MIL-M-28787/304A(EC)
AMENDMENT 3
13 July 1983
SUPERSEDING
AMENDMENT 2
16 September 1982

MODULES, STANDARD ELECTRONIC

MICROPROGRAM CONTROLLER, KEY CODE ZJU

FIGURE 8. Input clamp diode voltage test circuit for table VI.

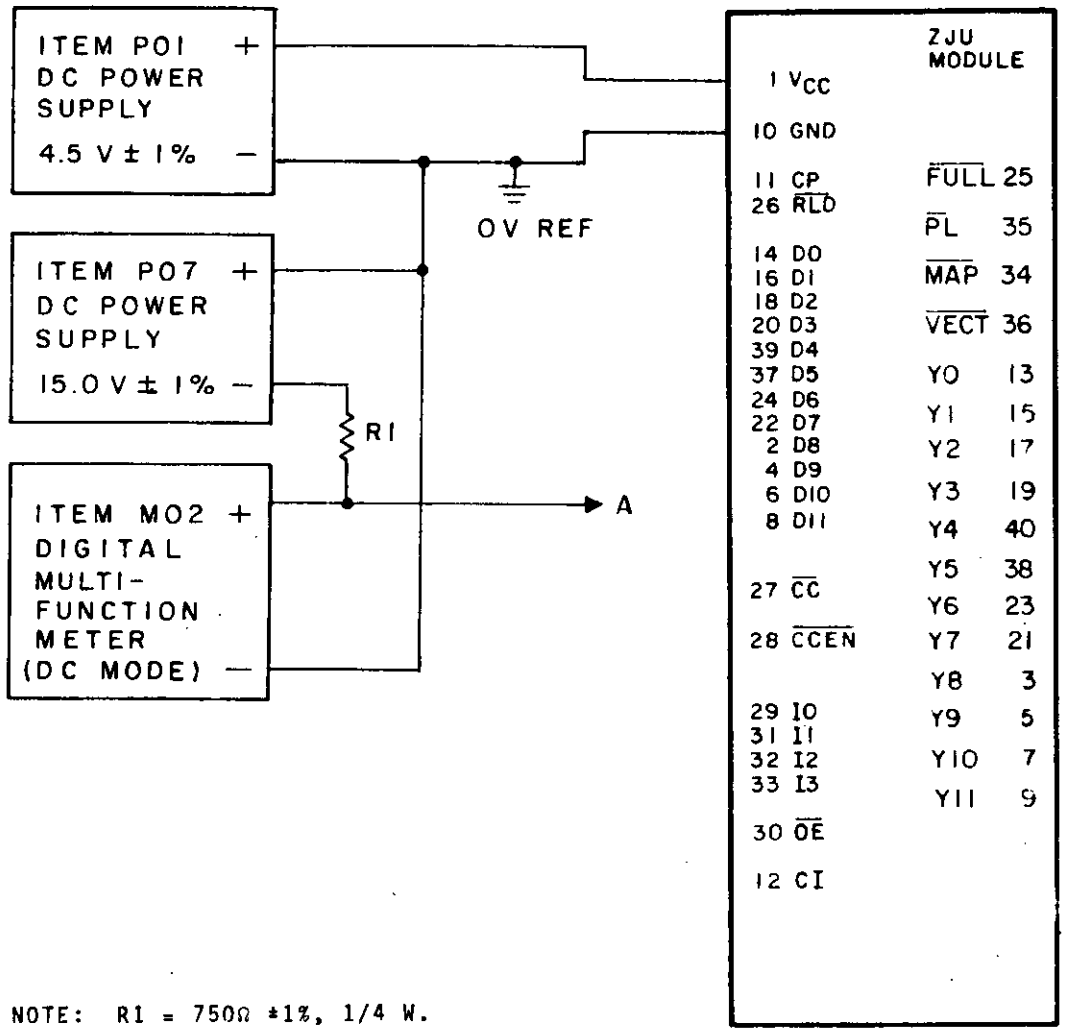
FIGURE 8: Delete and substitute new figure 8 as printed on page 5 of this amendment.

NOTE: R1 = 750Ω ±1%, 1/4 W.

FIGURE 11. Output voltage (high-level and low-level) test circuit for tables X and XI.

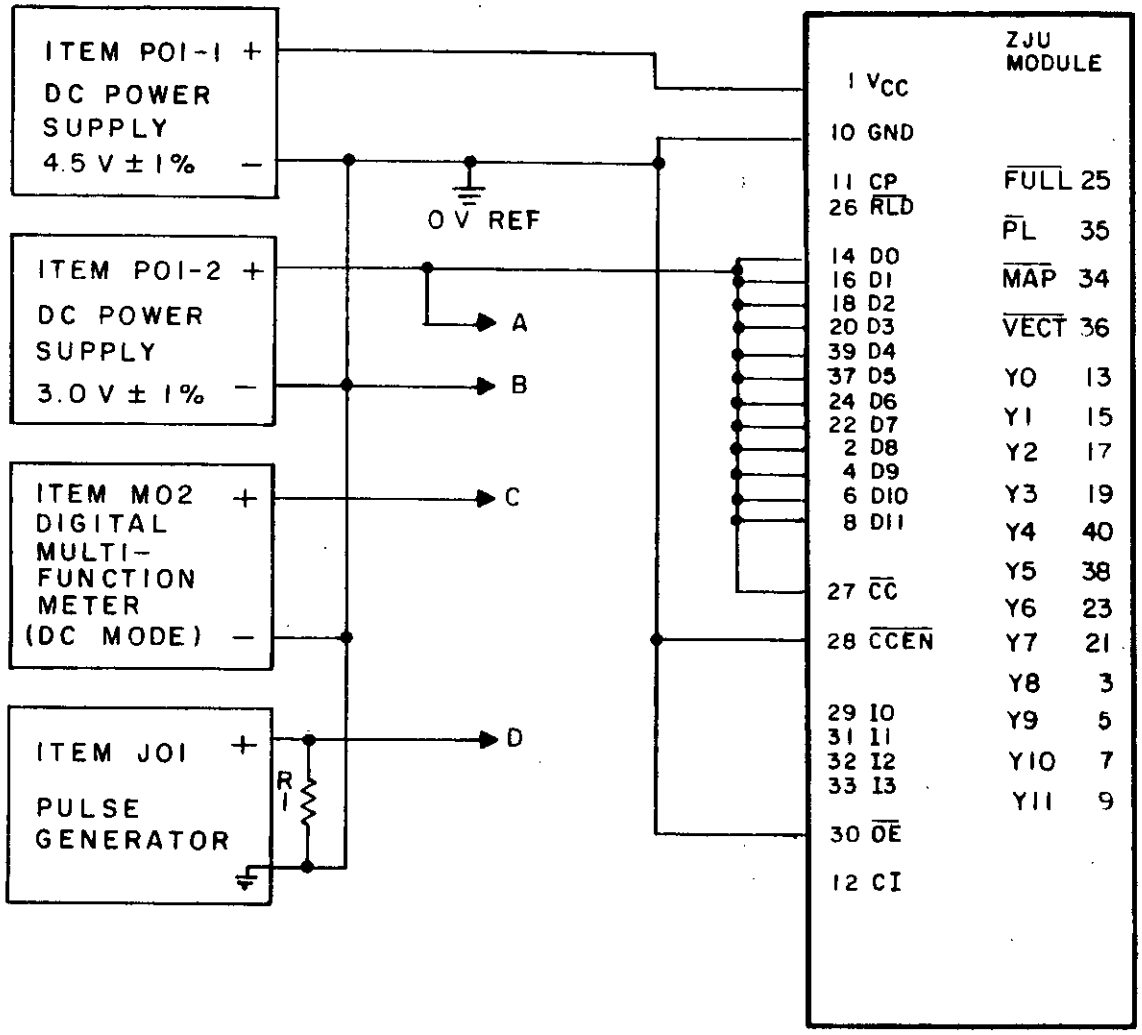
FIGURE 11: Delete and substitute new figure 11 as printed on page 6 of this amendment.

NOTES:
1. R1 = 51Ω ±5%, 1/2 W.
2. Load each output per figure 13.
3. Item J01 is used in single pulse mode. In test condition J16, apply 5 pulses as specified on figure 12.
